DECISION OF THE PLANNING COMMISSION

**CLASS 3 DESIGN REVIEW / CLASS 3 SITE PLAN REVIEW / CLASS 2
ADJUSTMENT / CLASS 2 DRIVEWAY APPROACH PERMIT CASE NO.: DR-
SPR-ADJ-DAP19-04**

REQUEST: A consolidated application for the relocation of the Ike Box (eating and drinking establishment) consisting of the proposed approximate 5,223 square-foot building, new vehicle use area, and modifications to driveways on Cottage Street and Court Street.

LOCATION: 220 Cottage Street NE / 97301

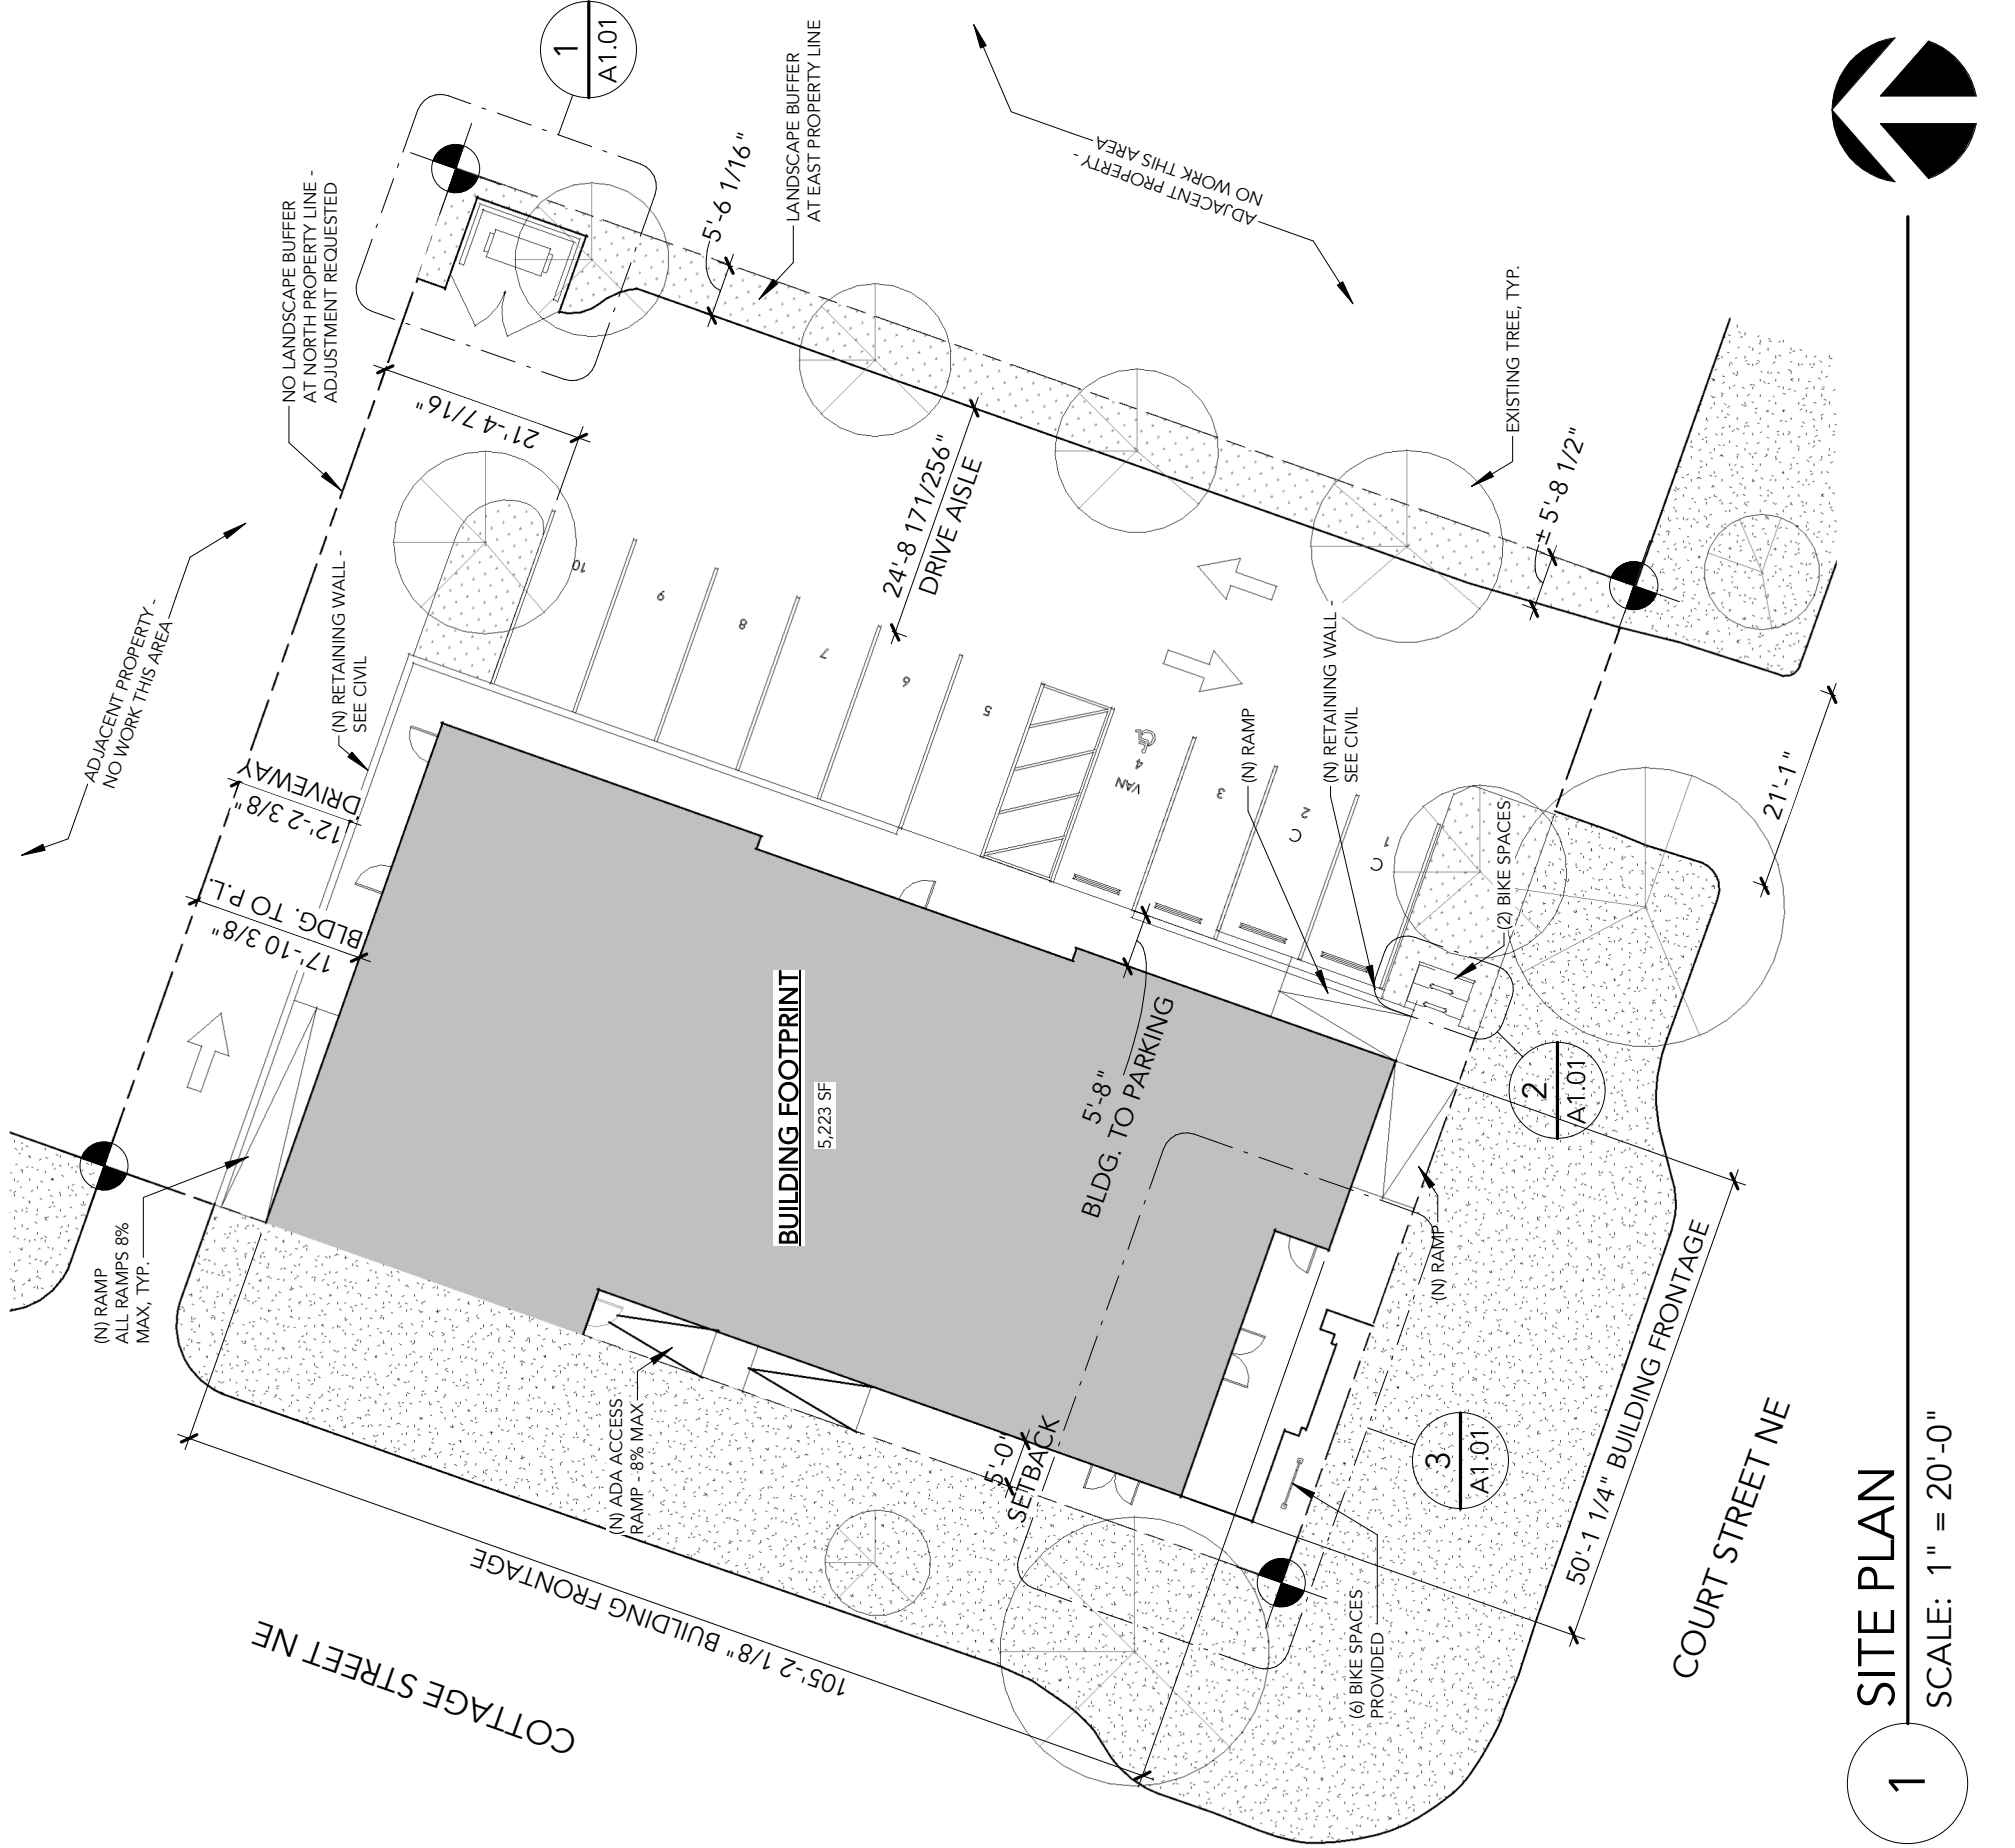
As shown on the site plan, the driveway leading to the vehicle use area is proposed to be 0-feet from the north property line, where 5-feet is required. Because the proposed surface parking lot/vehicle use areas adjacent to the north property line does not meet the minimum required setback, a Class 2 Adjustment to this standard has been requested as part of the application.

Development Site 15 percent. The applicant has provided as part of the site plan that the development site is 14,300 square feet, which requires 2,145 square feet of landscaping. The applicant is proposing 1,028 square feet or 7 percent of the development site. Because the proposal does not meet the minimum landscaping requirement, a Class 2 Adjustment to this standard has been requested as part of the application.

As shown on the site plan, a total of ten off-street surface parking spaces are provided within the proposed development. Based on the minimum tree planting requirement of 1 tree for every 12 parking spaces, the proposed parking area is required to include a minimum of one tree. As shown on the site plan for the proposed development, six trees are provided within the parking area on the plans, which satisfies the parking area tree planting requirements of SRC 806.035(d)(3).

As shown on the proposed site plan, the proposal will include a total of eight standard sized parking spaces and two compact sized parking spaces. The two compact spaces provided represents 20 percent of the overall 10 spaces provided; therefore not exceeding the maximum 75 percent limit.

Driveways. SRC 806.040(d) establishes minimum driveway width standards. Pursuant to SRC 806.040(d), Table 806-7, one-way driveways are required to have a minimum width of 12 feet and two-way driveways are required to have a minimum width of 22 feet. As shown on the proposed site plan, only two-way driveways are provided to serve the facility. The proposed driveway along the north property is for one-way traffic and greater than 12-feet. The second driveway for the most part exceed the minimum 22-foot required width. There is a small section where the landscaping projects into the 22-foot drive aisle. The following condition is to ensure two-way traffic can be accommodated on site:

Condition 1: The landscaping island abutting Court Street shall be reduced to provide a 22-foot wide drive aisle for two way traffic.

1 SOLID WASTE REC.
SCALE: 1/8" = 1'-0"

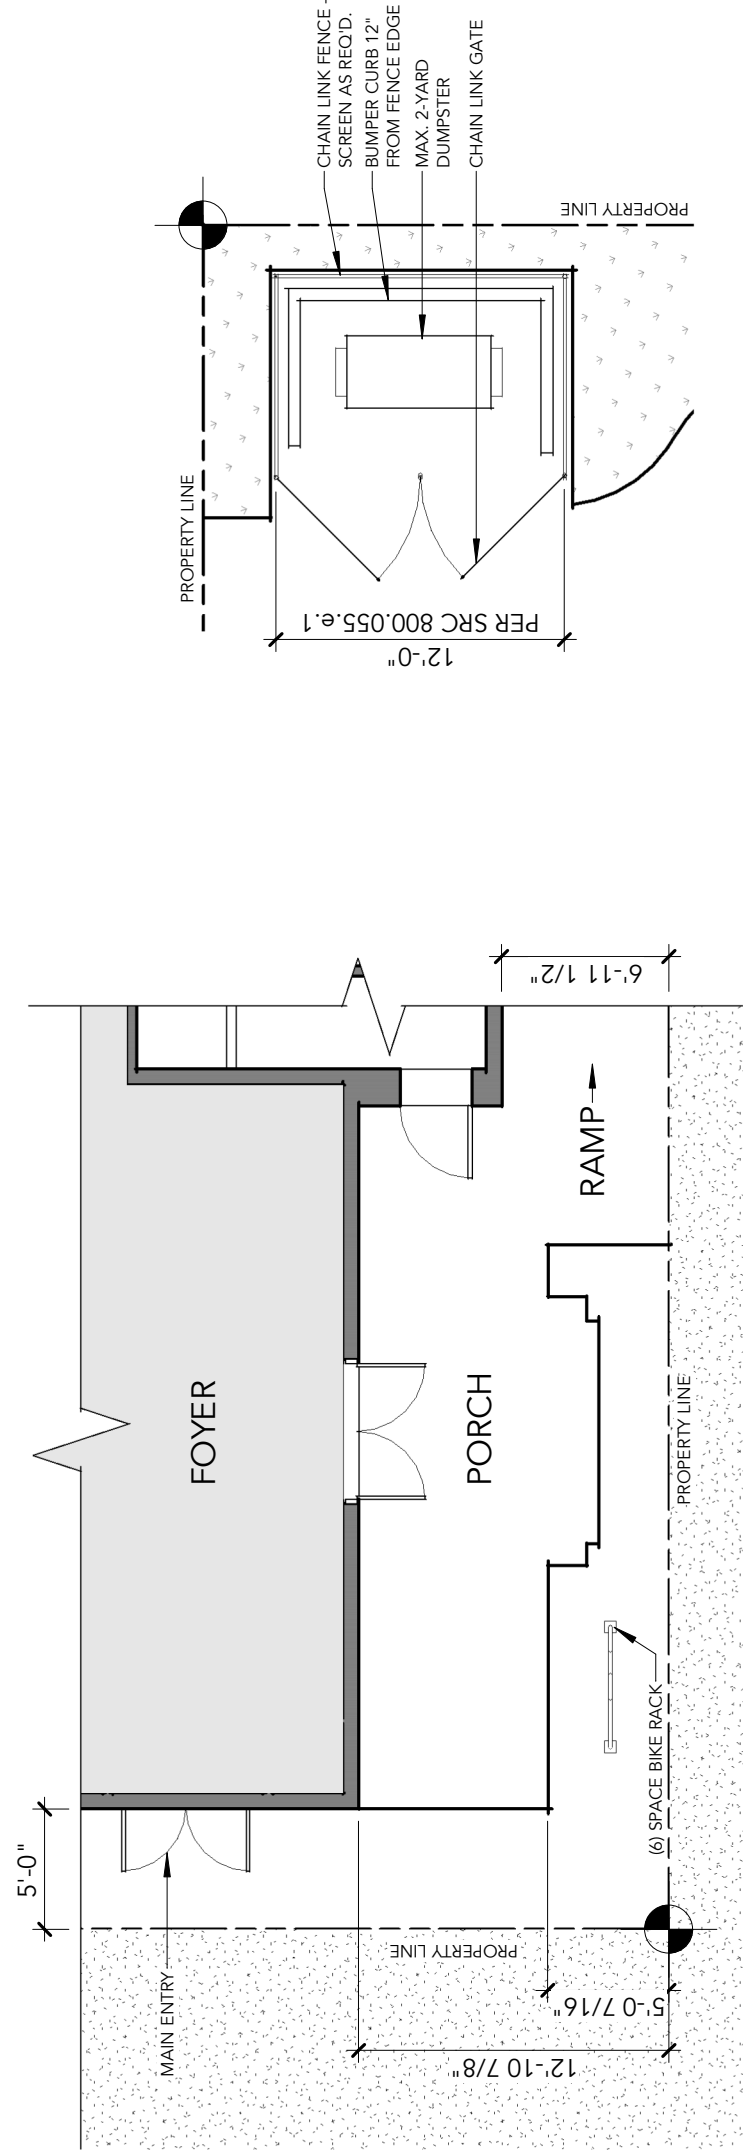
As shown on the site plan for the proposed development, the solid waste service area is uncovered, enclosed by an six-foot-tall perimeter wall, has an interior dimension within the enclosure of approximately 12ft in. in width by 8 ft.-6 in. in depth, has a front opening of 12 feet, and is free of vertical obstructions above the receptacles.

Because the solid waste service area is proposed to be uncovered it is also subject to Administrative Rule 109-012 Appendix D which requires a Trash Area Management Plan.

Condition 2: The trash/recycling area shall conform to the solid waste service area standards of SRC 800.055.
